dsPIC33FJ06GS101/X02 and dsPIC33FJ16GSX02/X04

dsPIC33FJ06GS101/X02 and dsPIC33FJ16GSX02/X04 Family Silicon Errata and Data Sheet Clarification

The dsPIC33FJ06GS101/X02 and dsPIC33FJ16GSX02/X04 family devices that you have received conform functionally to the current Device Data Sheet (DS70000318G), except for the anomalies described in this document.

FIGURE 1: TIMING DIAGRAMS FOR CENTER-ALIGNED AND EDGE-ALIGNED MODES

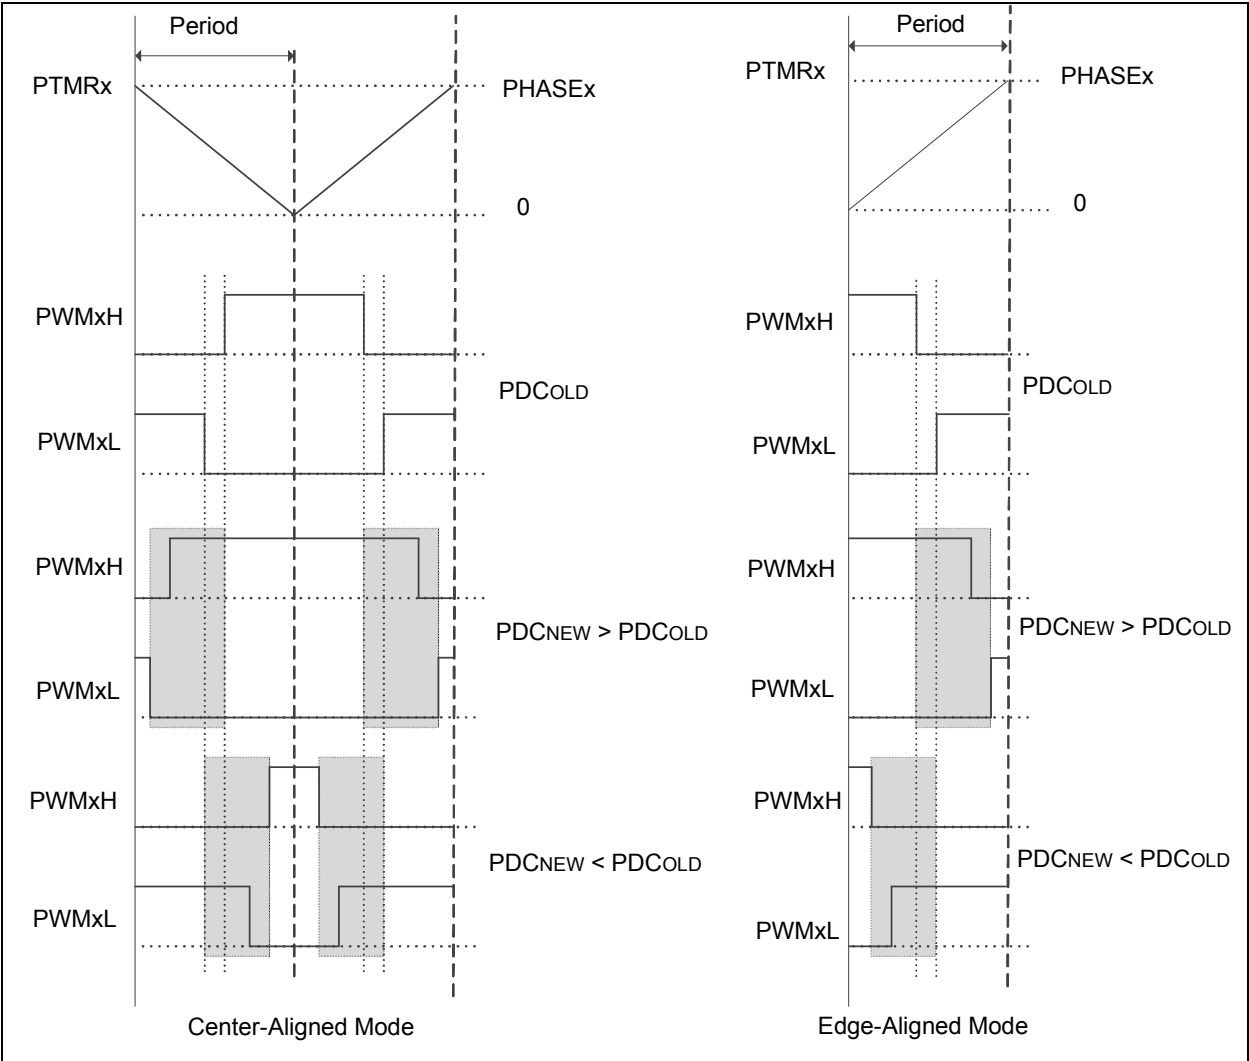
In [Figure 1](#) (following page), if the duty cycle write occurred in the shaded box, then PWMxH and PWMxL will make an immediate transition without dead time.

FIGURE 2: ISSUE EXAMPLE FOR REDUNDANT OUTPUT MODE

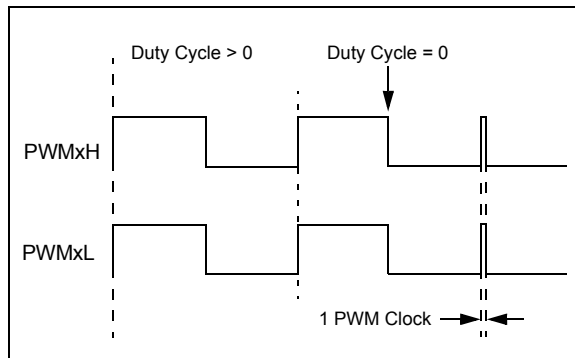
In Redundant Output mode (IOCONx[11:10] = 01) and Push-Pull Output mode (IOCONx[11:10] = 10), with the Immediate Update disabled (PWMCONx[0] = 0), when the Duty Cycle register is updated from a non-zero value to zero, a glitch pulse of a width equal to 1 PWM clock will appear at the next PWM period boundary, as shown in Figure 2 (for the Redundant Output mode). The Duty Cycle register refers to the PDCx register if PWMCONx[8] = 0 or the MDC register if PWMCONx[8] = 1.

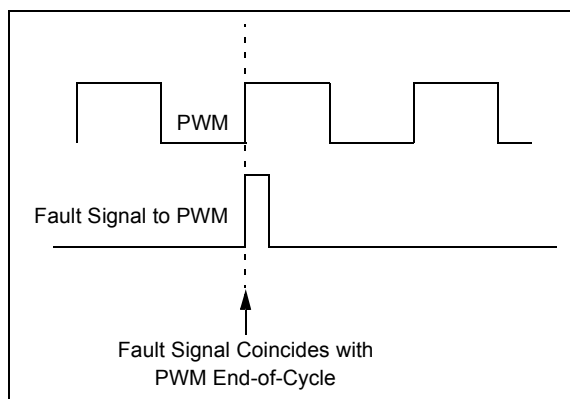
When the PWM module is operated in Complementary, Redundant, Push-Pull or True Independent Output modes and the PWM Fault/Current-Limit Fault are configured to provide a Fault event to the PWM, under certain conditions where the Fault event active edge happens to coincide with the PWM End-of-Cycle (EOC) event, the PWM fails to recognize the Fault event.
